**HISTORIC LANDMARK COMMISSION
APPLICATION FOR A CERTIFICATE OF APPROPRIATENESS
DECEMBER 16, 2019
C14H-1986-0008
SCARBROUGH BUILDING
522 CONGRESS AVENUE**

Install signage on the ground floor of the building for Velvet Taco, a new restaurant.

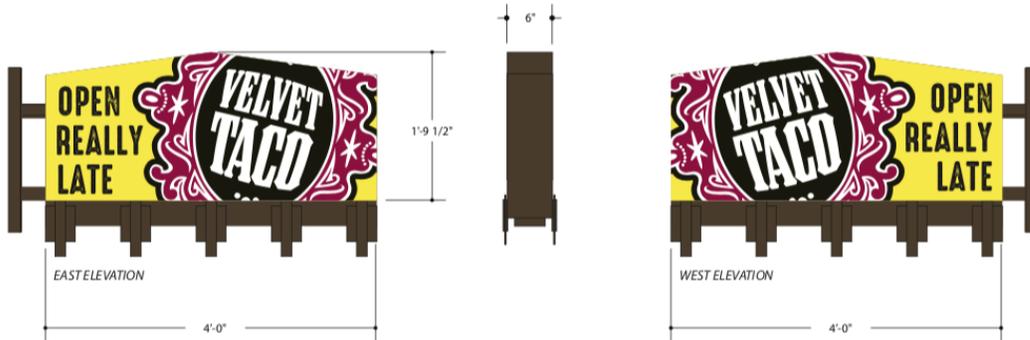
Yes on the existing sign, we will be affixing panels that are 1'9.5" H at the highest point, as depicted below. This will leave the existing metalwork at the bottom of the sign exposed.

We are using dimensions off the sign that we took last month - as shown in the attached image

The above sign is a refacing of the existing blade sign on the building that comports with the overall sign program for the building and will be approved administratively.
